Subject: **Response to NRC Request for Information regarding the Review of the Sequoyah Nuclear Plant, Units 1 and 2, License Renewal Application, Set 25 (TAC NOS. MF0481 and MF0482)**

**Responses to NRC Requests for Additional Information regarding Sequoyah
Nuclear Plant Unit 1 License Renewal**

RAI 3.0.3.2.17-1a (Surveillance Capsule Operating Experience Followup)

Figure 1

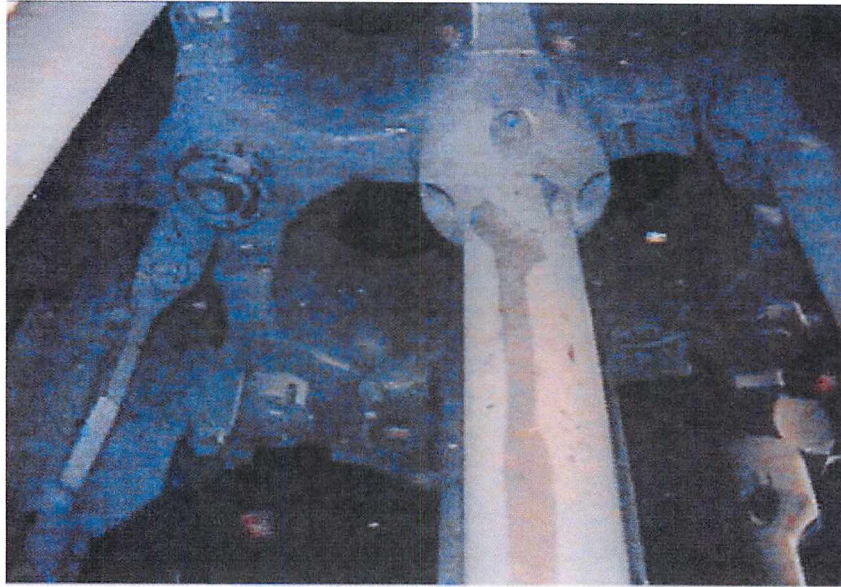
(1) Provide an adequate technical justification for not considering the potential effects of loose part-induced cold work on the likelihood of degradation of the damaged reactor internals, in particular the long term prospects for initiation of stress corrosion cracking in the damaged internals.

- The stress at the location of the rub mark on the instrument guide extension G-5 (see Figure 1) was evaluated. The stress was calculated to be well below 5 ksi even if a hypothetical reduction in depth of 5% is assumed along with a conservative stress concentration factor. Thus, the rub on the instrument guide extension would not have an impact on the potential for cracking in this component.
